TRANSPORTATION ADVISORY COMMITTEE

December 19, 2024

RE: Grand Terrace Residential Development TIA-Response to ODOT Comments

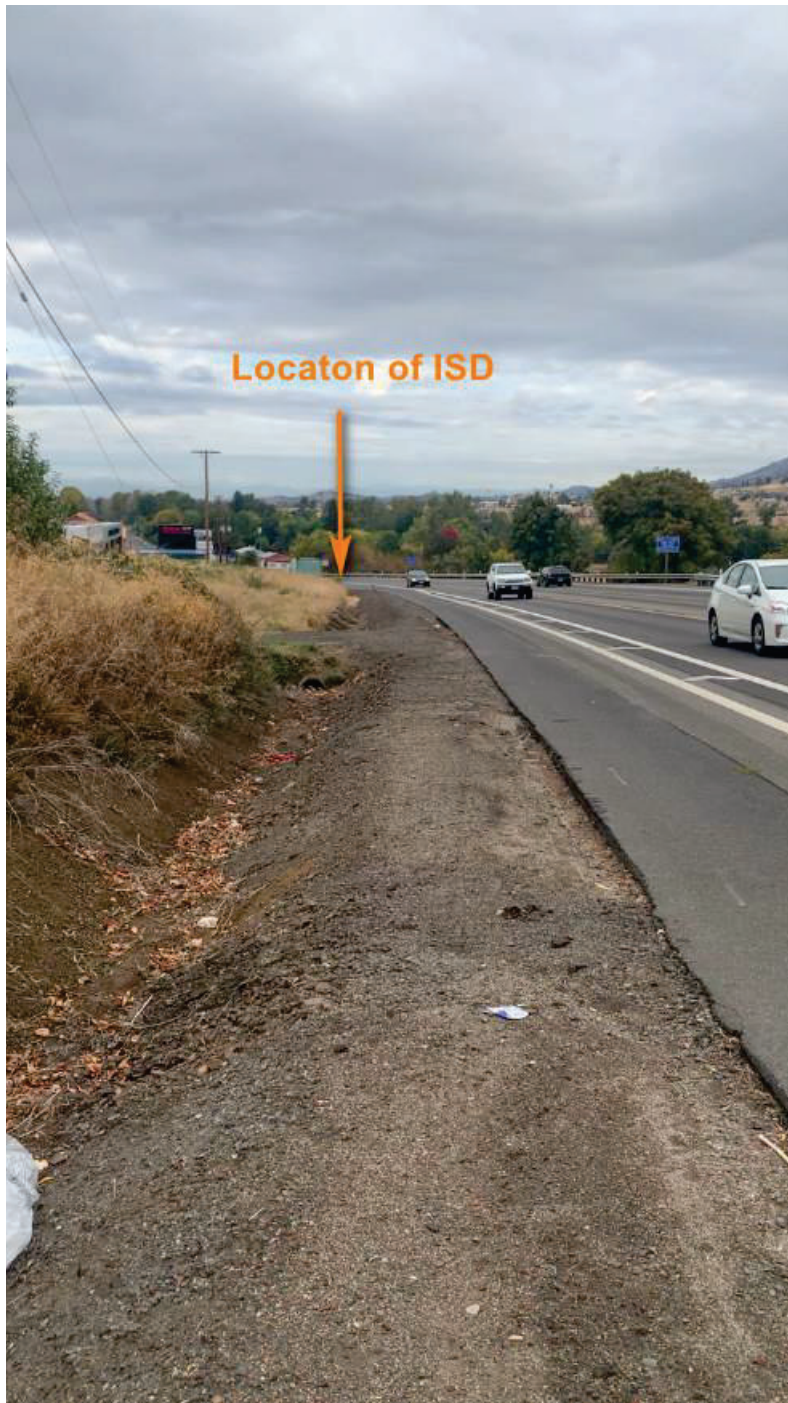
The AASHTO Methodology is to measure the ISD from the typical driver position at 14' back from the travel way. The available ISD to the north was measured at 569 feet, and the available ISD to the south was measured at 577 feet. The ISD requirements are met. Figure 1 provides an illustration of the ISD measurement. The images 1 and 2 below illustrate the field verification photos.

The field verification of the ISD and SSD at the site access was performed by Sandow Engineering on October 8, 2021 and is in compliance with the jurisdictional authority, the Oregon Department of Transportation.

ISD requirement location looking north from site access. ISD is met
